GOVERNMENT OF THE DISTRICT OF COLUMBIA
DEPARTMENT OF TRANSPORTATION

MEMORANDUM

SUBJECT: BZA Case 19113 – 1000 South Capitol Street SE

Figure 1 Site Plan (Source: Gorove/Slade)

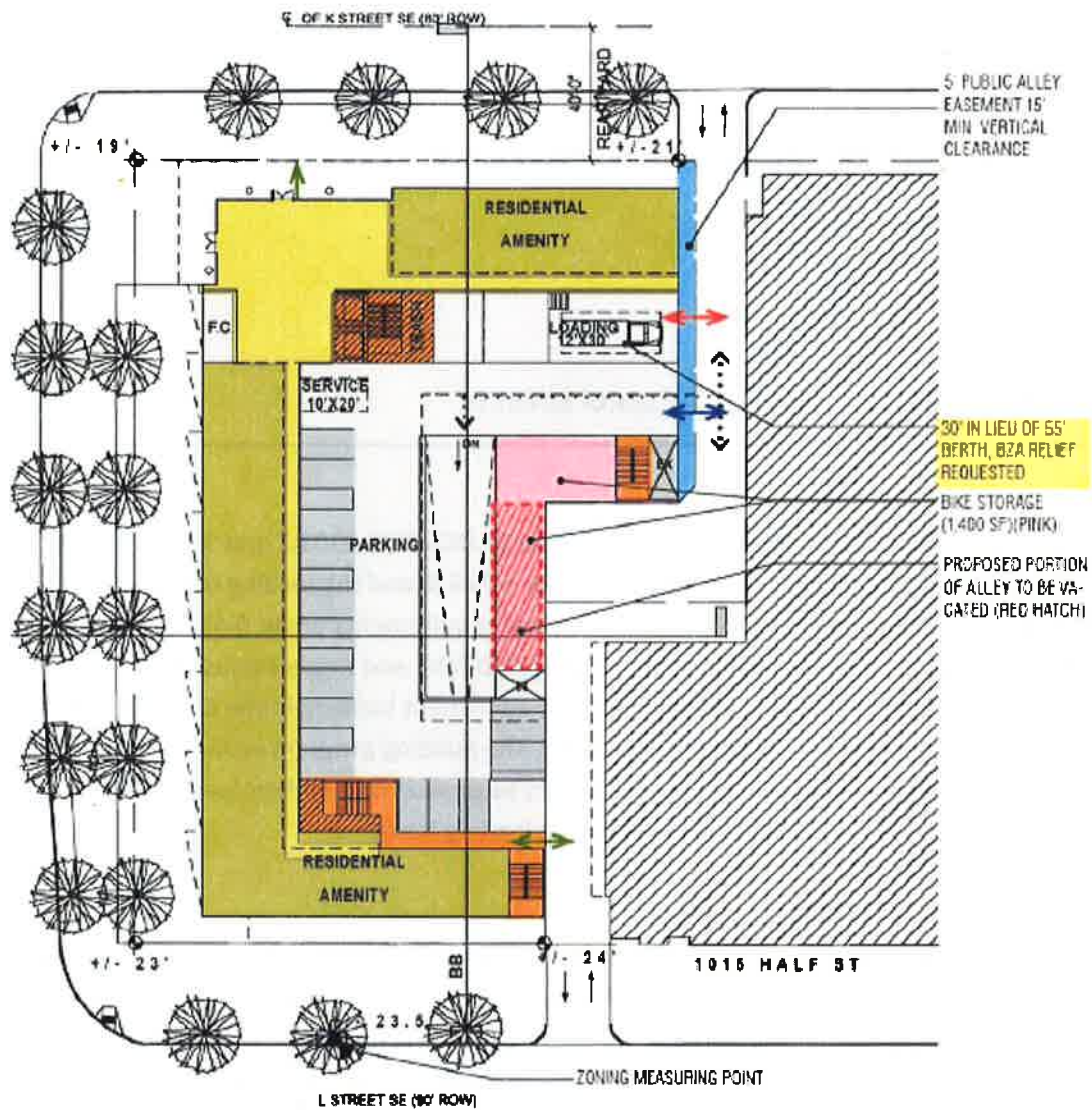
Site access for vehicle parking and loading is proposed from a public alley to the east of the site, as shown in Figure 1. The Applicant proposes to widen the northern portion of the alley to 20 feet with a 5-foot easement to connect to K Street. An existing 20-foot alley easement connects to L Street. The

Applicant provided truck turning diagrams showing that the proposed loading layout accommodates front-in/front-out movements, in keeping with DDOT's Design and Engineering Manual (31.2.3.2). As part of a separate action with the District, the Applicant proposes to close a stub portion of alley adjacent to the site and incorporate it into the subject site. The Applicant provided truck turning diagrams showing that closing the alley segment would not impede truck movements for the subject site or the neighboring property, and the Applicant is seeking approval to close the alley concurrently with the zoning relief.
